## Planning Commission Vote Report

**Subject:** Zoning Map Amendment

**Petition:** **P.Z. 04-2016 US Ice Sports Complex & Valley Gates (Topgolf USA Chesterfield LLC)**: A request for a zoning map amendment from an existing “PC” Planned Commercial District to a new “PC” Planned Commercial District for 22.22 acres located north of North Outer 40 Road and east of Boone’s Crossing (17T510041, 17T520062, 17T520095, 17T520084).

**RE: PZ 04-2016 U.S. Ice Sports Complex and Valley Gates  
(Topgolf USA Chesterfield LLC)**

SHEET NO.:
C1

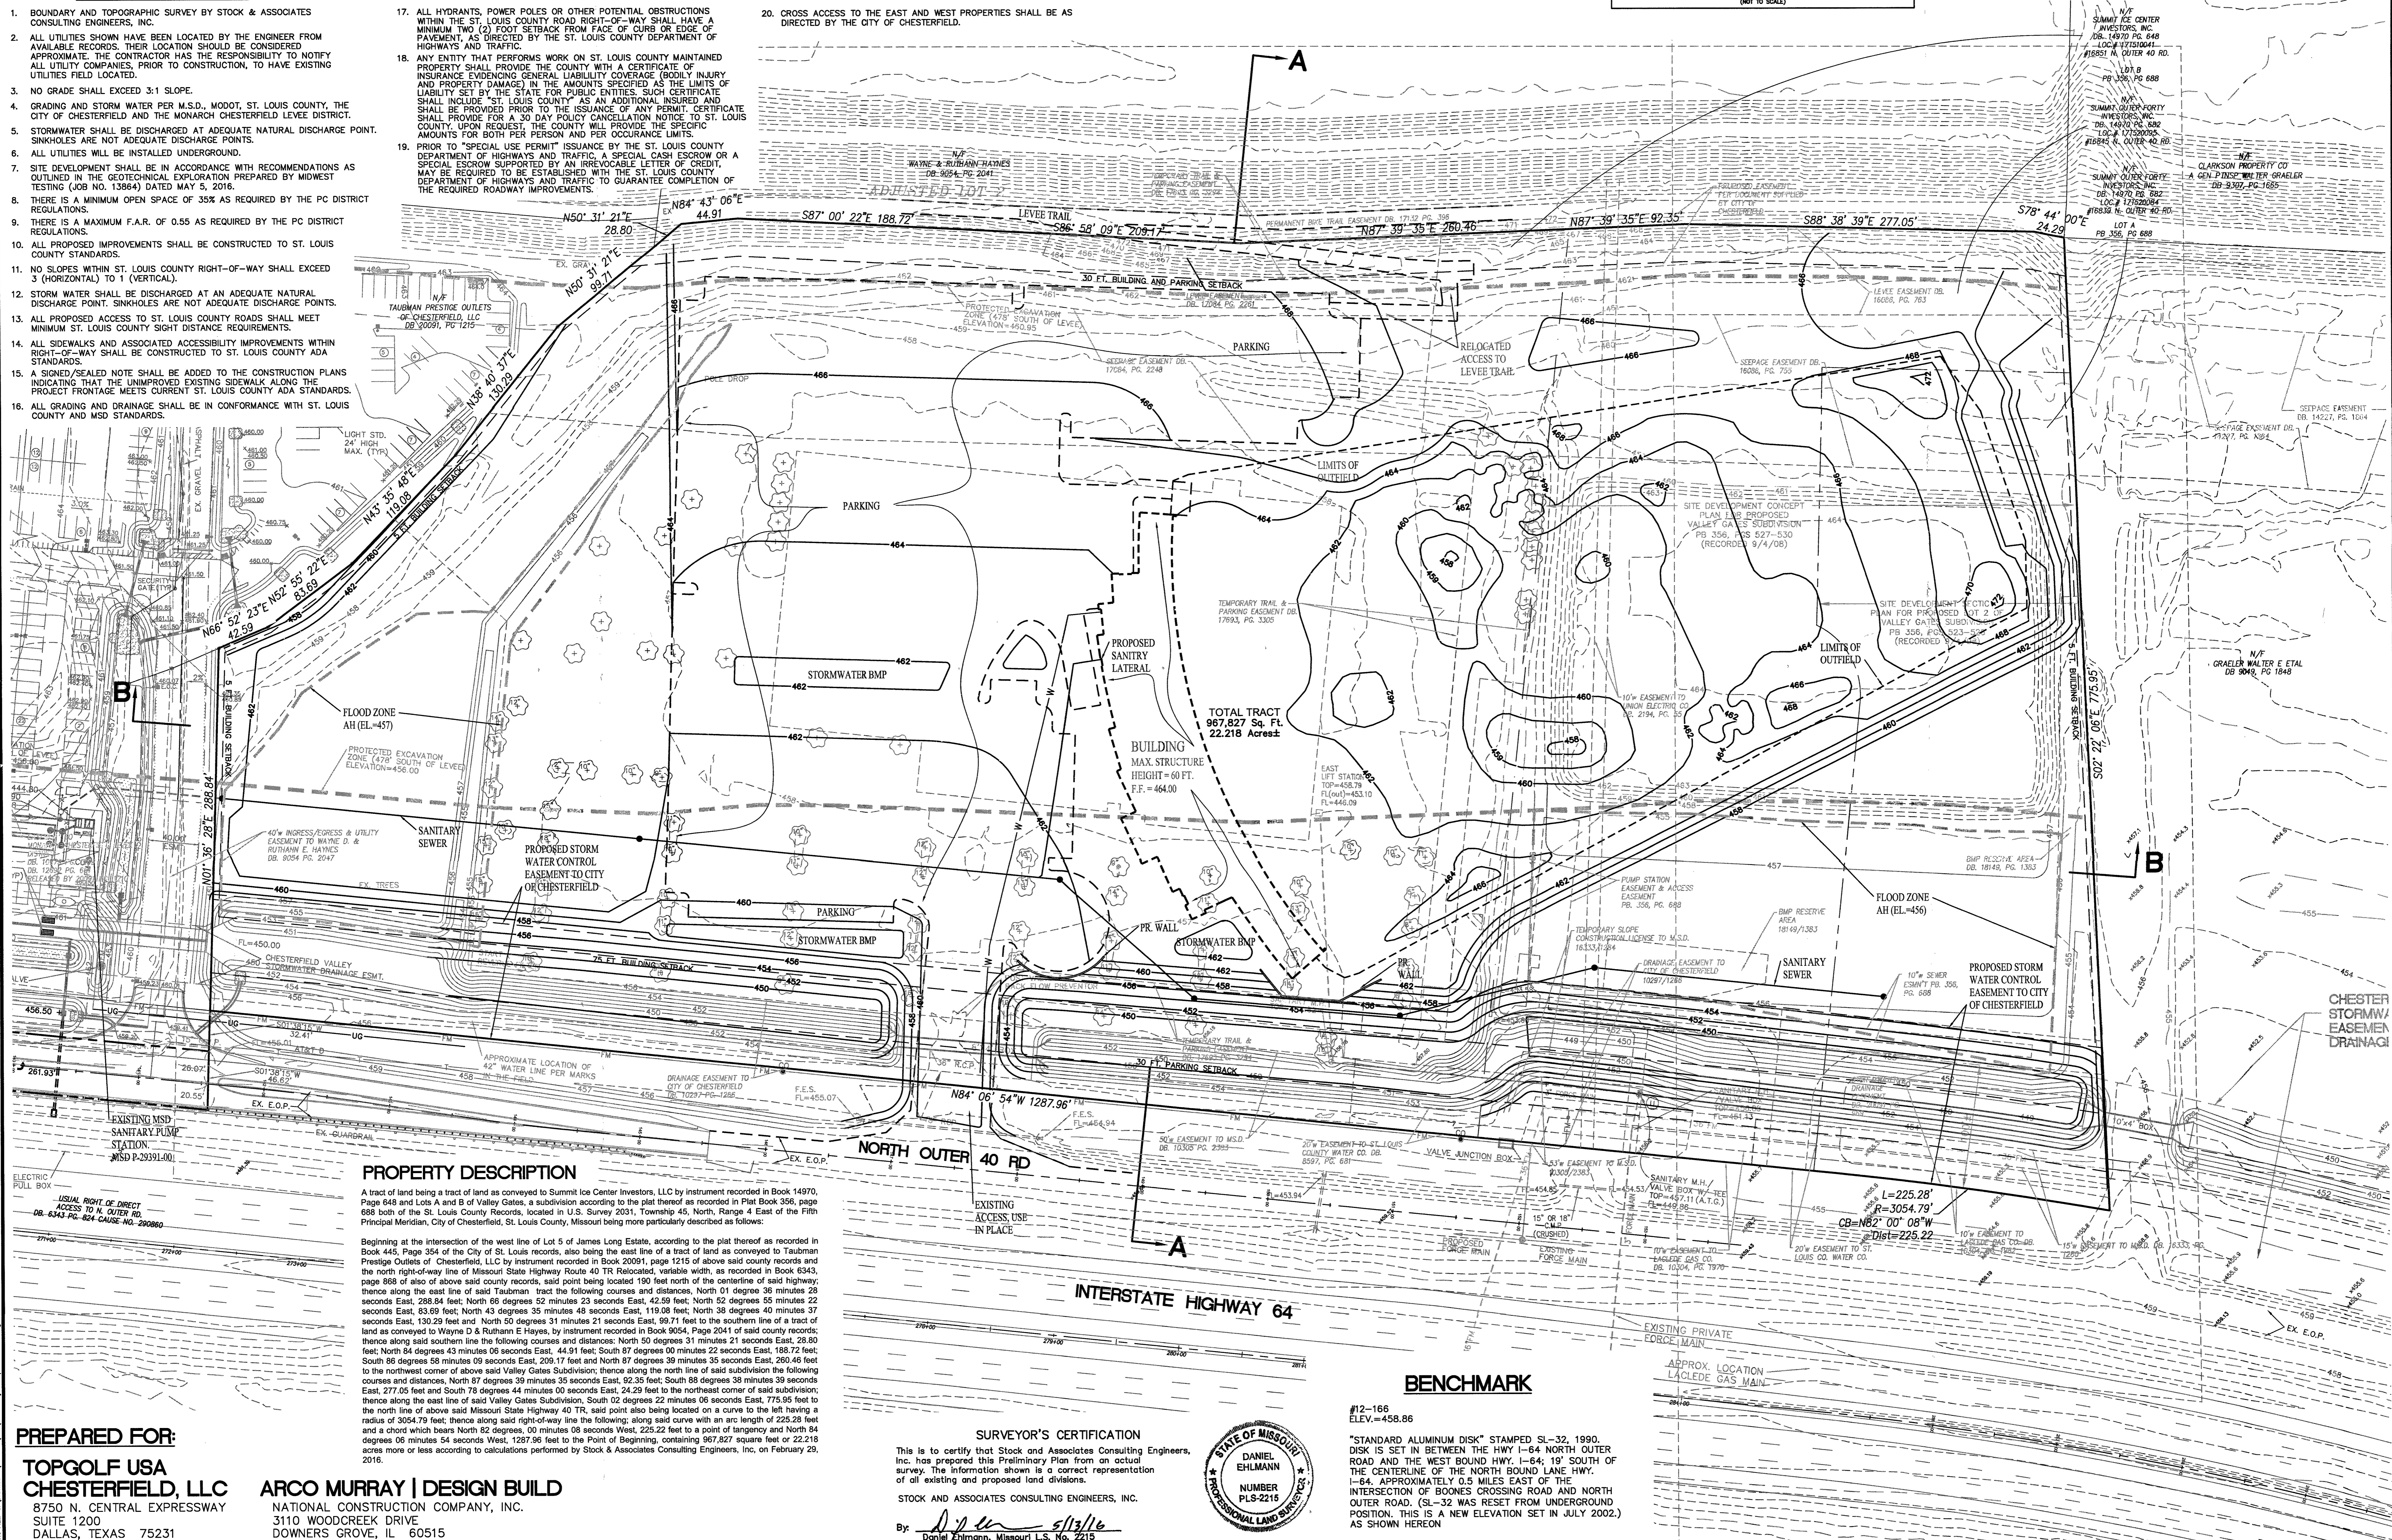
3. *Cross access to the adjacent properties to the east and west should be addressed.*

The petitioner has no current plans to develop the acreage of the subject site that is not devoted to the Topgolf operations as proposed on the attached Preliminary Plan. However, Staff has included a requirement that cross access shall be provided to the properties to the east and west as directed by the City. This requirement is included in the Attachment A as well as on the Preliminary Plan.

4. Cross access shall be provided to serve the properties to the east and west of the subject site, as directed by the City of Chesterfield.
